DATA REQUEST CHECKLIST FOR LETTER OF MAP REVISION BASED ON FILL

Property Location: SW Corner Teal Brook Estates, Sec 12, T27S, R2W

Re: Teal Brook Estates Fill
Cowskin Creek
NW NE 12-T27S-R2W
DWR-8162

Re: S/D 88-57 Teal Brook Estates
Preliminary Plat

EXHIBIT "A"

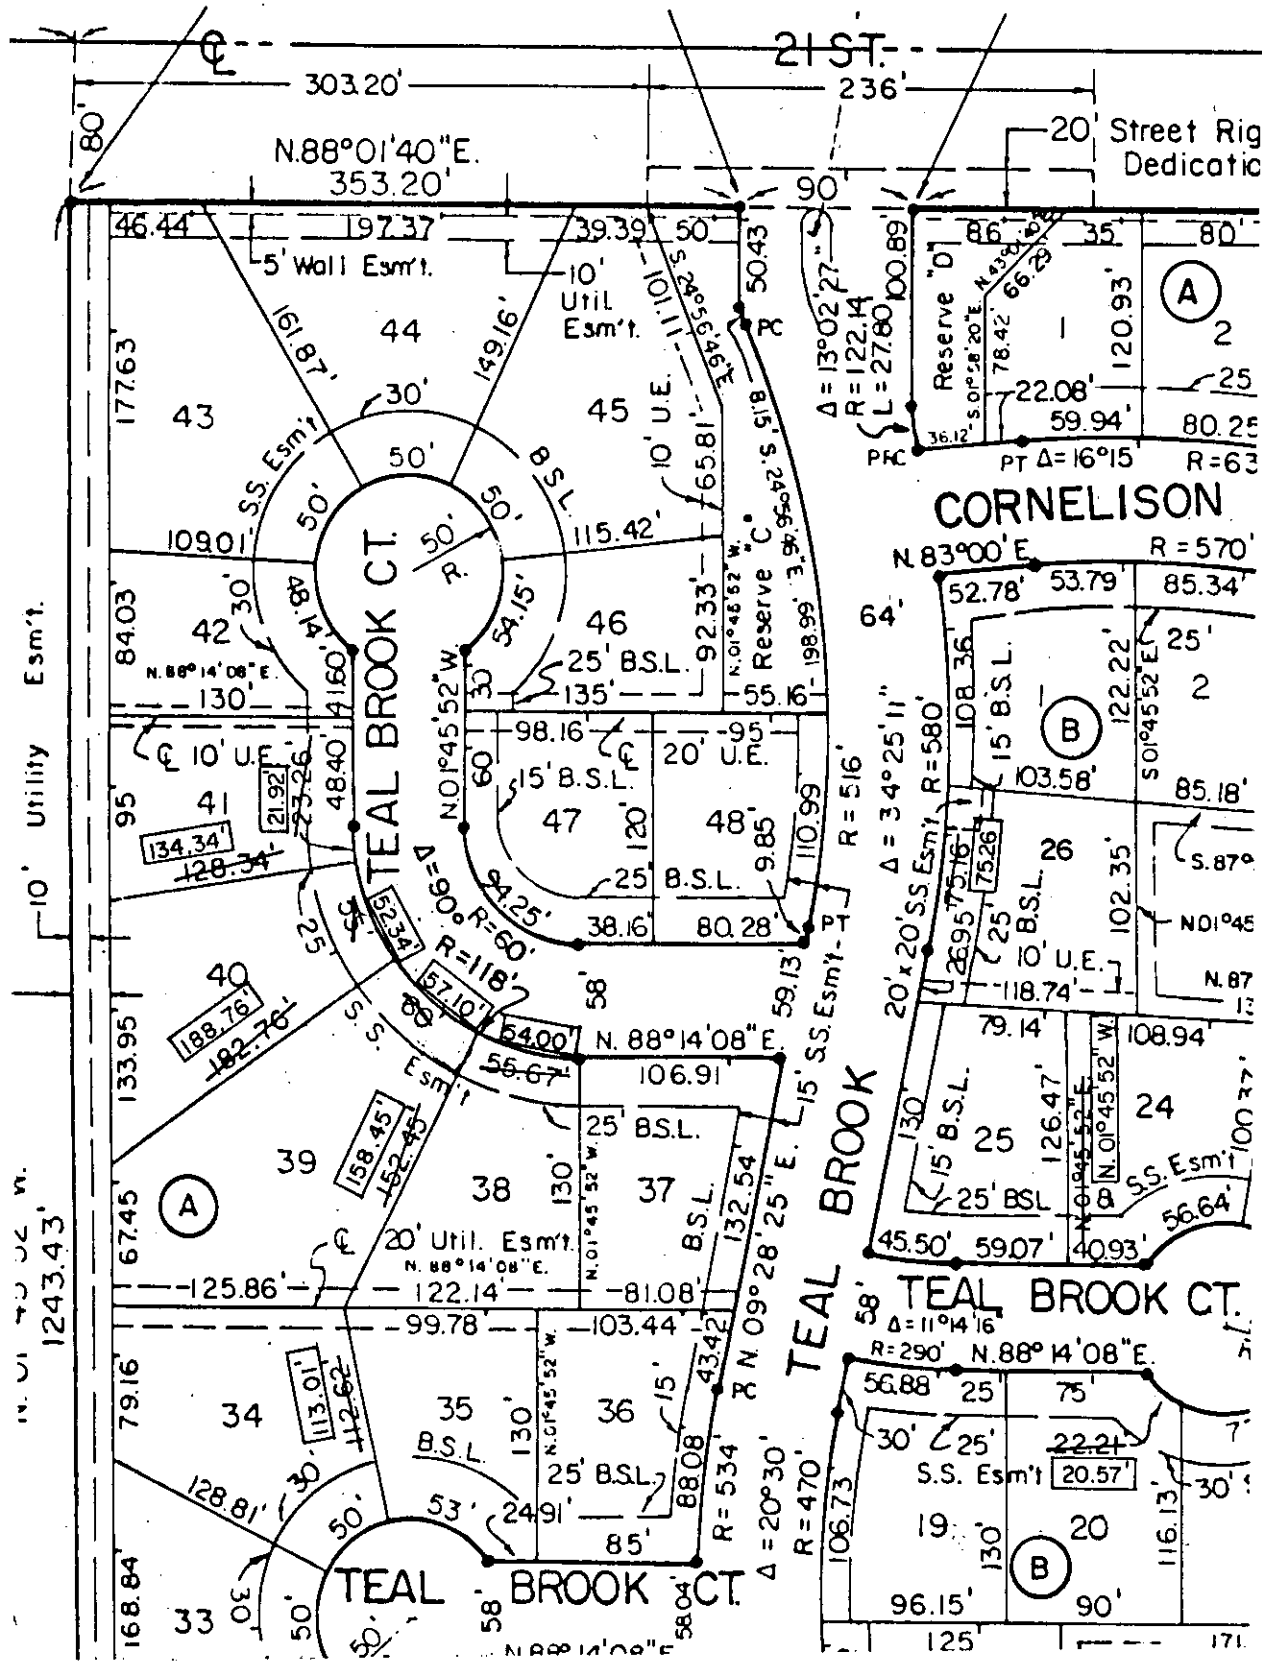
Lot 41, Block A
~~23.26'~~
 [21.92'] corrected

EXHIBIT "B"

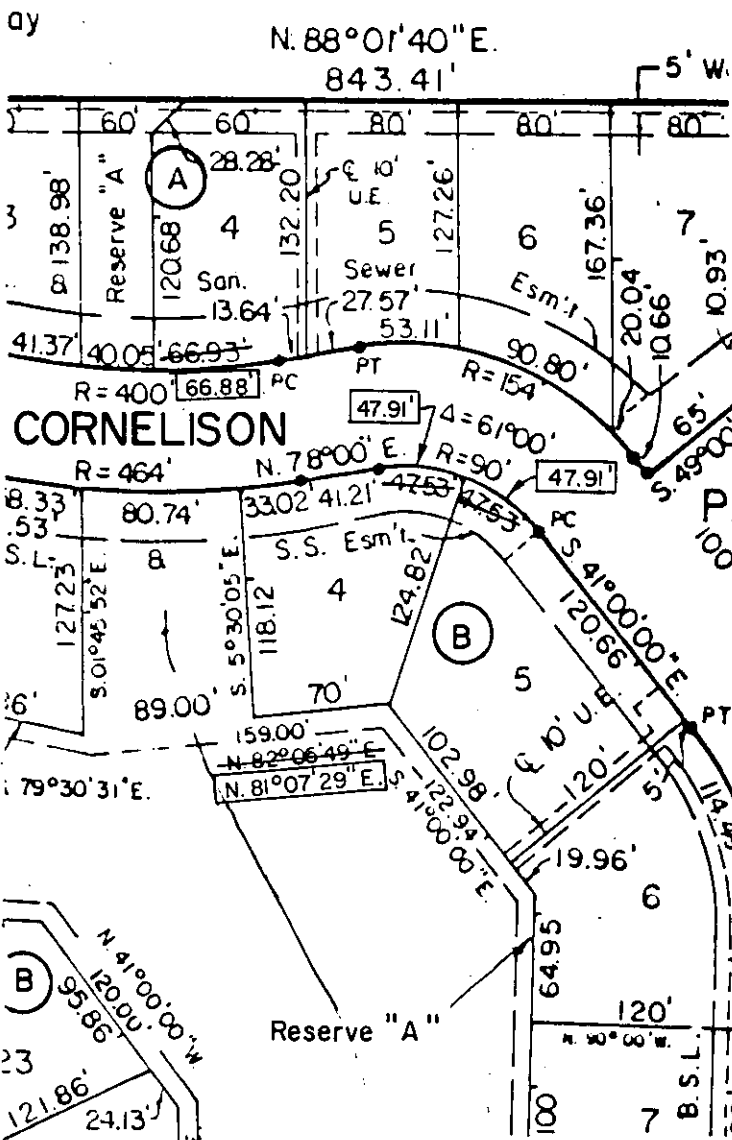
Lot 4, Block A

~~66.93'~~ deleted

EXHIBIT "A"

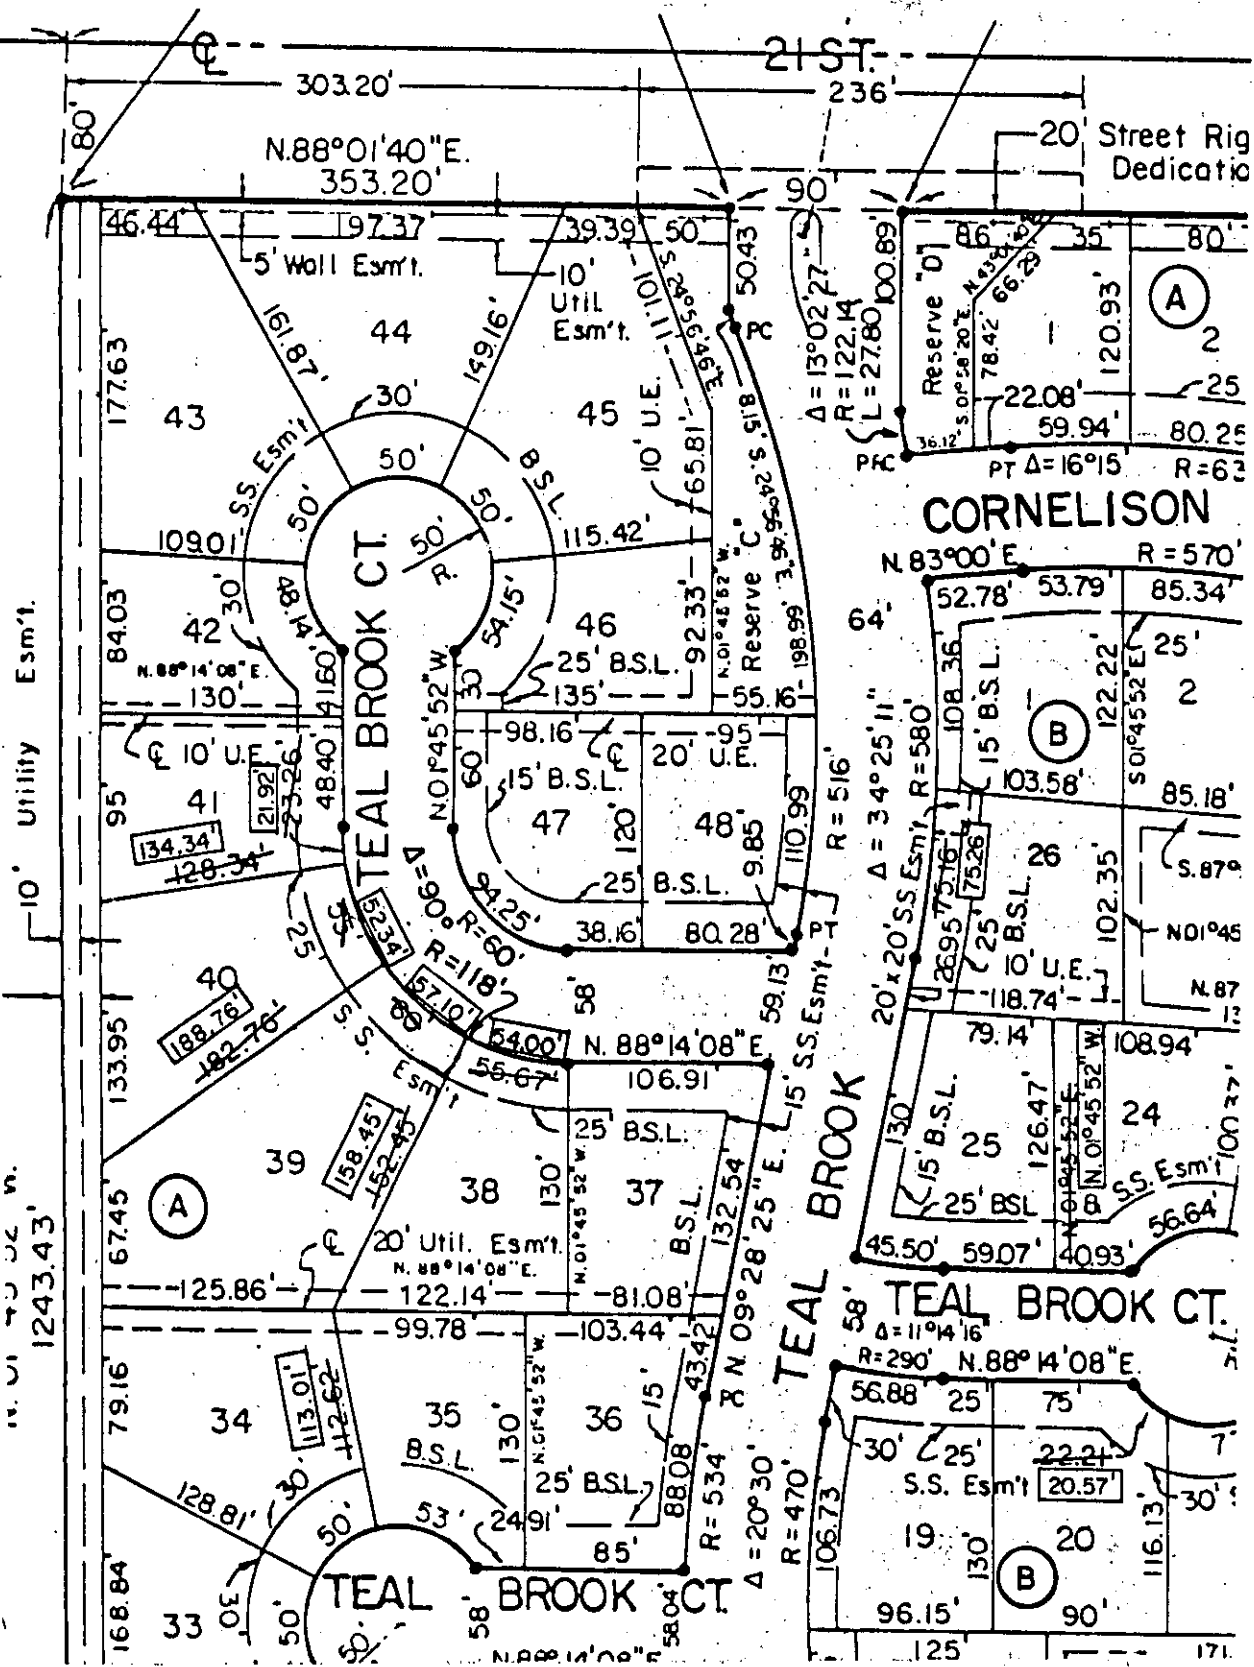
| <p><u>Lot 40, Block A</u>

-182.76' deleted
 <u>188.76'</u> corrected</p> | <p><u>Lot 34, Block A</u>
 -112.62' deleted
 <u>113.01'</u> corrected</p> | |

EXHIBIT "B"

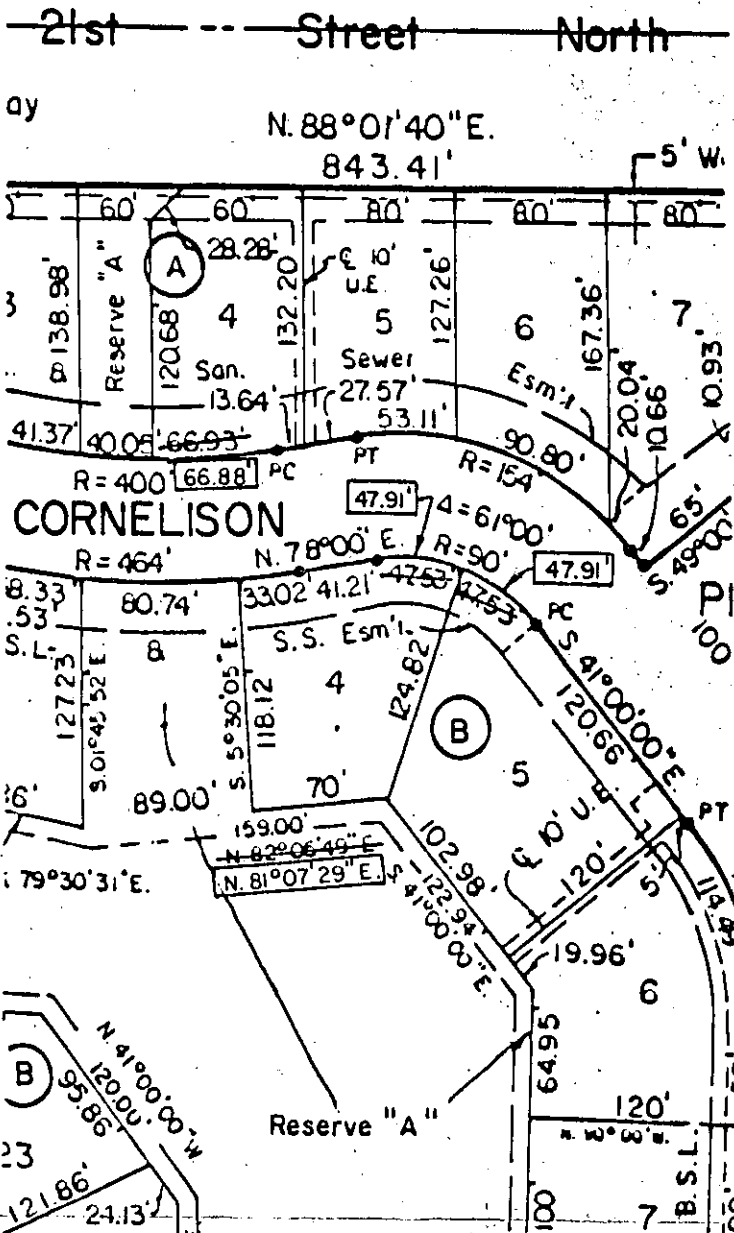
Lot 4, Block A
~~66.93'~~ deleted
 [66.88'] corrected

EXHIBIT "A"

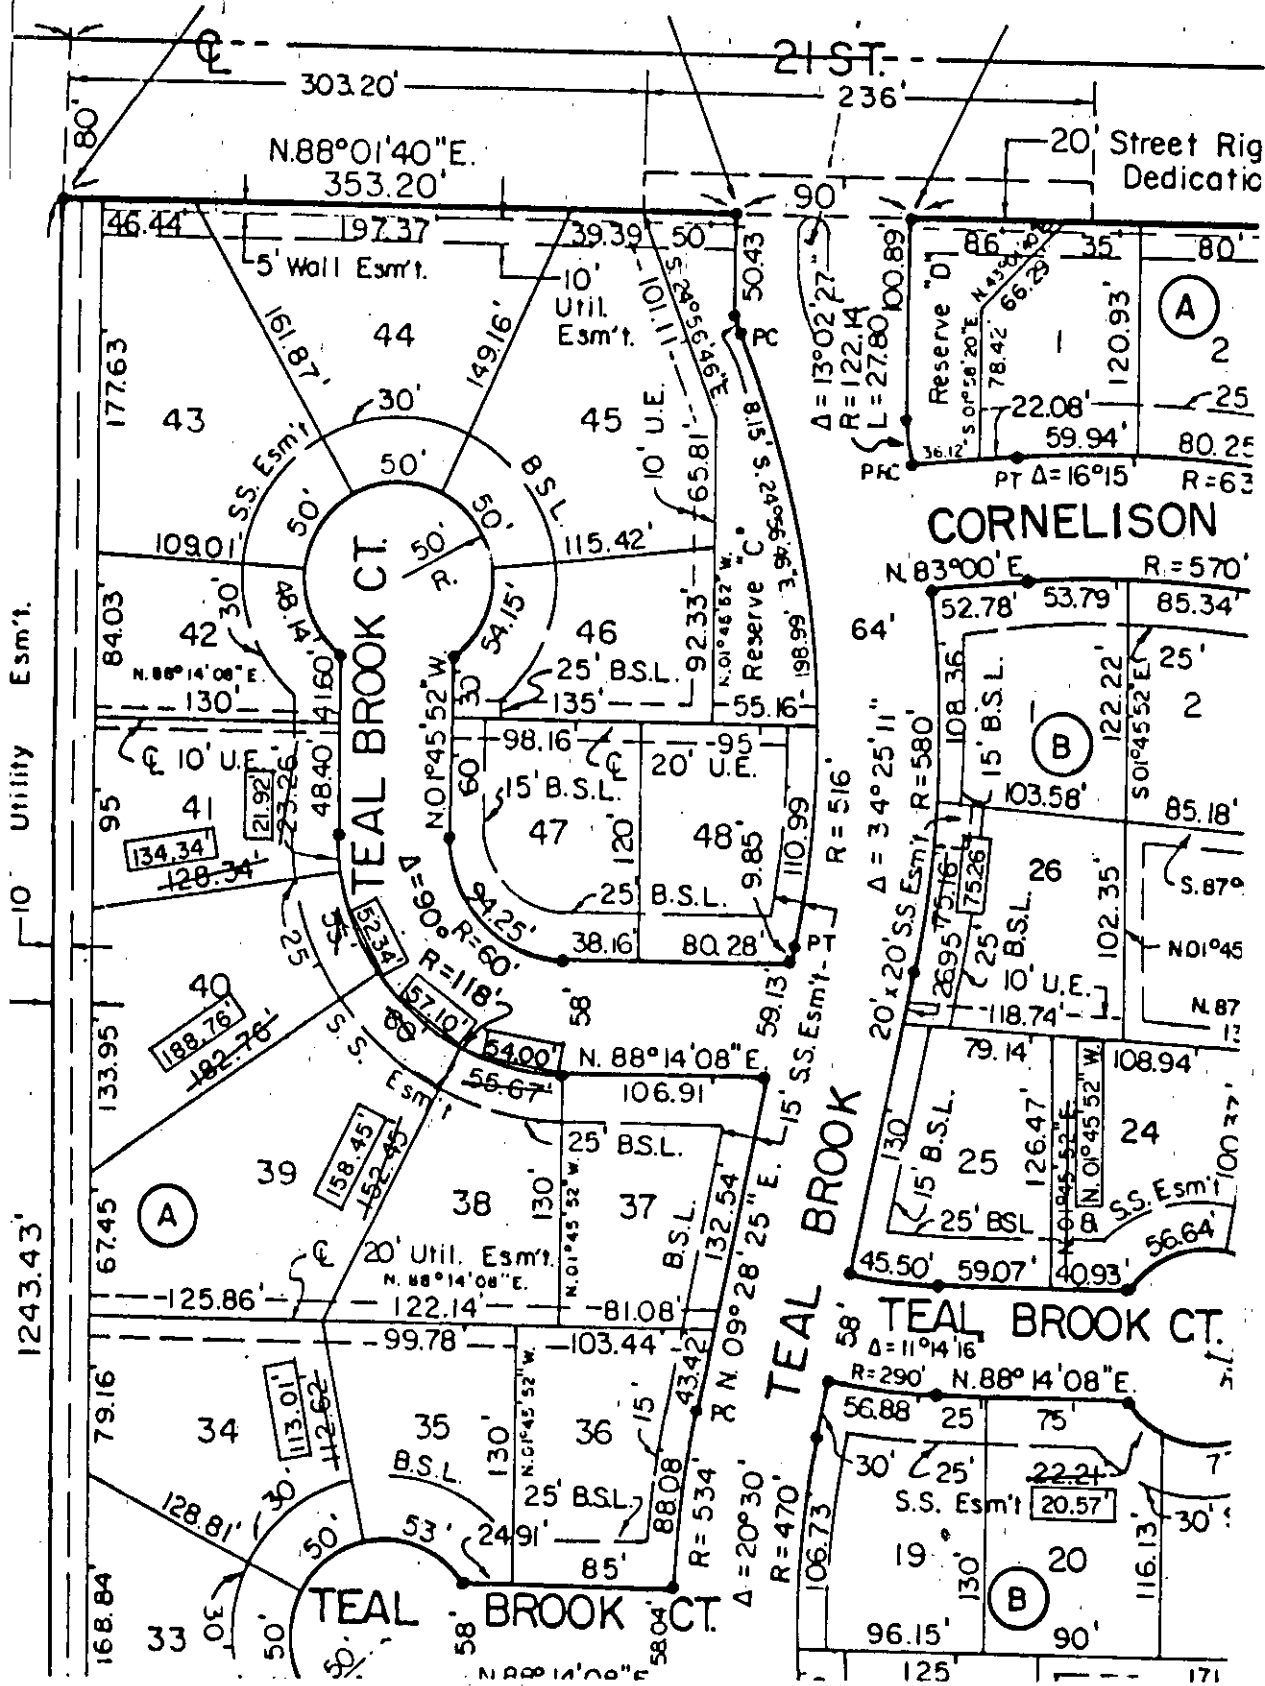
Lot 41, Block A
~~-23.26'~~
 [21.92'] corrected

Lot 40, Block A
~~-182.76'~~
 [188.76'] corrected

Lot 34, Block A
~~-112.62'~~
 [113.01'] corrected

EXHIBIT "B"

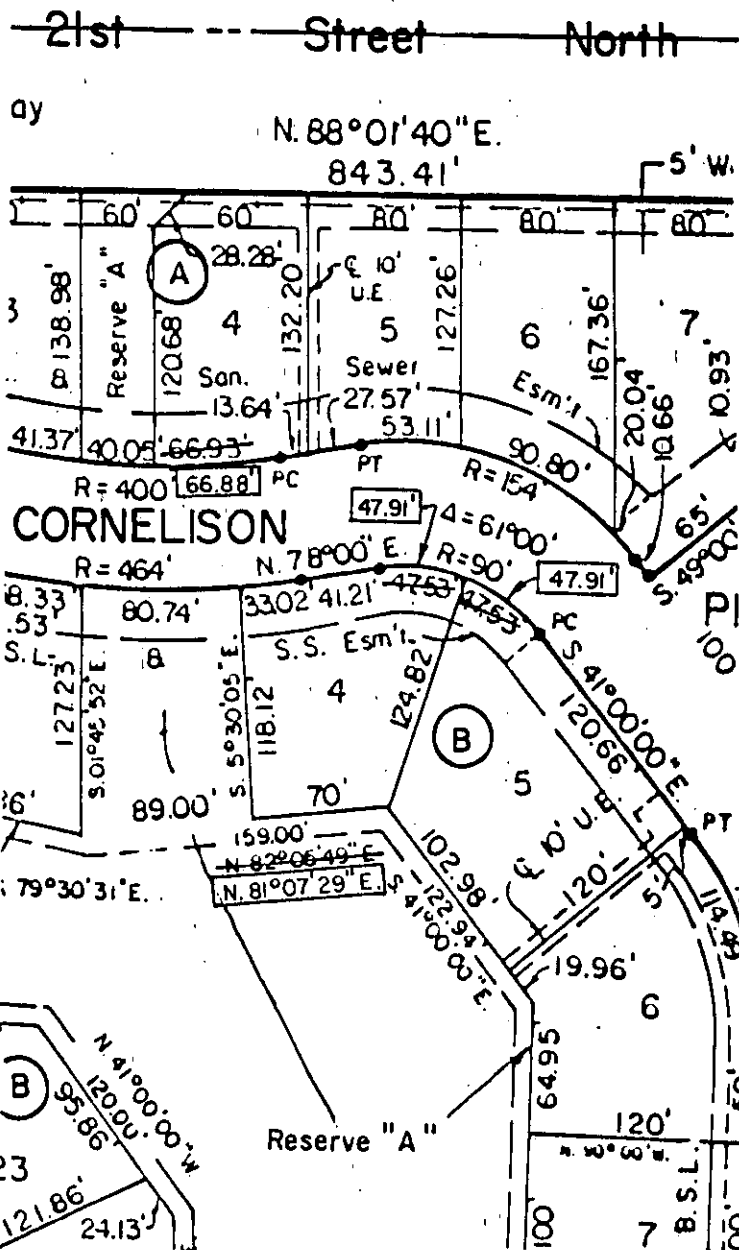
Lot 4, Block A

47.91 corrected

Lot 4, Block B

~~N. 82°05'49" E.~~ deleted

N. 81°07'29" E. corrected
